# Minnesota Department of Natural Resources

April 21, 2008

RE: Application for Pipeline Routing Permit for the Alberta Clipper and Southern Lights Diluent Projects.  
PUC Docket NOs PL95/PPL-07-361

Photo 9

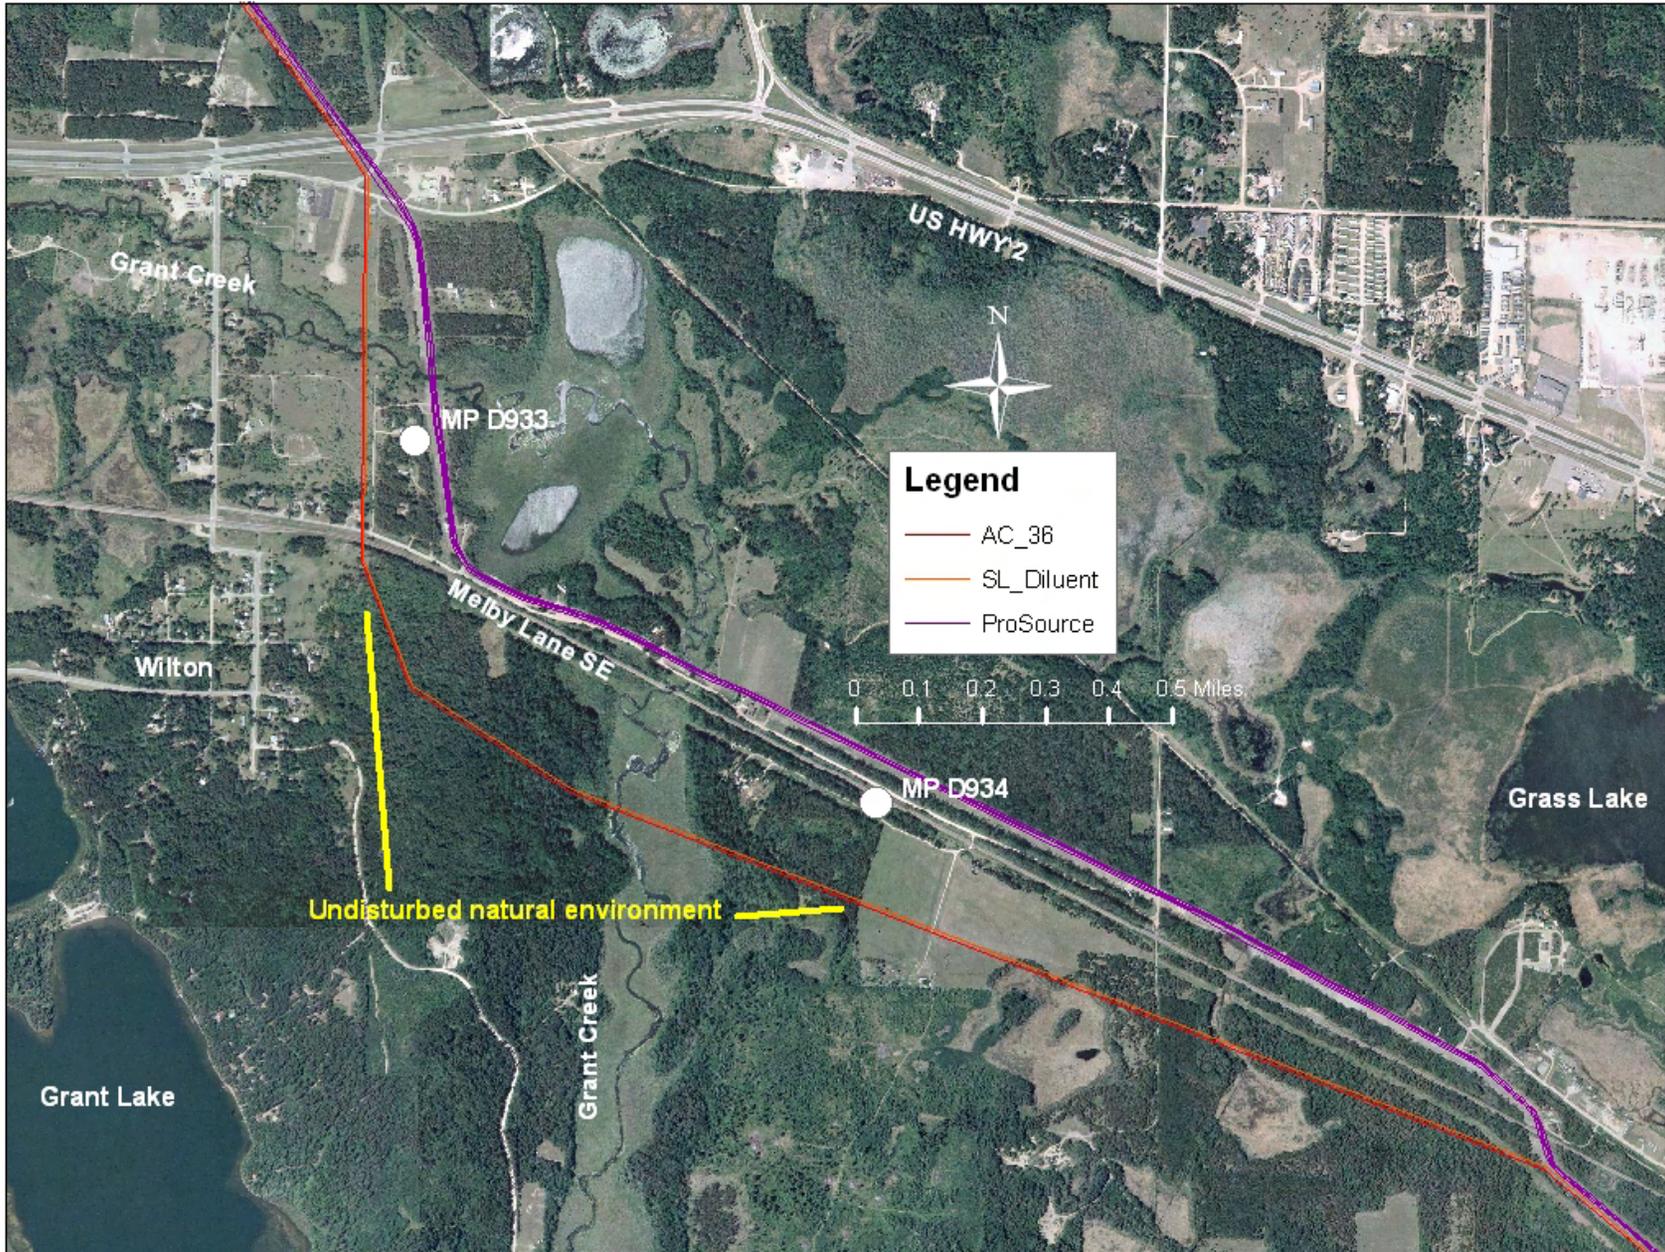
with this characterization, and contends that the new alignment on a greenfield route is adverse in each of these categories compared with the June 2007 route. This is clearly demonstrated on aerial photos and even a cursory look in the field (See Photographs 9 and 10, Attachment 2.)

Enbridge will need to apply licenses to cross two locations of Grant Creek. At this time, Enbridge has not supplied sufficient information for us to determine if the proposed location is justified; in fact, as noted here, this proposal has a high impact to natural resources as compared to the June 2007 filing. We recommend that Enbridge:

--Search for and examine a route that does not open a large new corridor across an undamaged natural wetland and Grant Creek section south of Spike Lane.

--If Enbridge were to continue to propose this route, to supply a detailed route comparison from immediately south of US 2 (About MP932.6) to MP 935.3 using much more accurate information regarding the natural environment than was evidenced in the CEA. DNR will be asking for this comparison during a review of the Grant Creek crossing proposals. DNR will need a site specific plan for the route segments for the creek crossing, including the vegetated river corridor, surrounding wetlands, and any staging areas to be used for the crossing.
